Access Compliance Report Public Rights-of-Way (Curb Ramps)

Main Street: **CARTHAGE_ST** Cross Street: **TUNISIA_CIR** Location: **SW**

ADA ID: **RPAT210917134521** Ramp Type: **Type 1 - Perpendicular Diagonal Initial Pass/Fail: Fail** Overall Compliance: **No** Severity Score: **2**

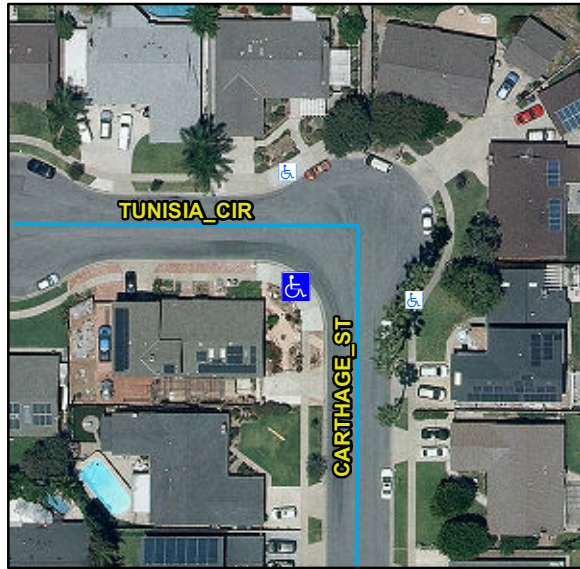
Compliance	Description	Data	Compliance	Description	Data
N/A	Ramp Length (in)	65	N/A	Flare Type LT	
Yes	Ramp Width (in)	48			N/A
Yes	Ramp Run Slope (%)	6.6	N/A	Flare Slope LT (%)	N/A
No	Ramp Cross Slope (%)	2.6	N/A	Flare Traversable LT	N/A
N/A	Landing Present	N/A	N/A	Flare Type RT	
N/A	Landing Length (in)	N/A			N/A
N/A	Landing Width (in)	N/A	N/A	Flare Slope RT (%)	N/A
N/A	Landing Run Slope (%)	N/A	N/A	Flare Traversable RT	N/A
N/A	Landing Cross Slope (%)	N/A	N/A	DWS Provided	N/A
N/A	Landing Movement Obstructed?	N/A	N/A	DWS Contrast	N/A
	Landing Movement Type	N/A	N/A	DWS Length (in)	N/A
N/A	Landing Shared	N/A	N/A	DWS Full Width	N/A
N/A	Clear Space	Yes	N/A	DWS Offset Left (in)	N/A
N/A	Clear Space To Crosswalk (in)	N/A	N/A	DWS Offset Right (in)	N/A
N/A	Marked Crosswalk 1	No	N/A	Marked Crosswalk 2	No
	Crossing 1 Direction	E		Crossing 2 Direction	N
	Marked Crosswalk 1 Width (in)	N/A		Marked Crosswalk 2 Width (in)	N/A

Remove & Replace Curb Ramp With Two New Directional Ramps or Equivalent.
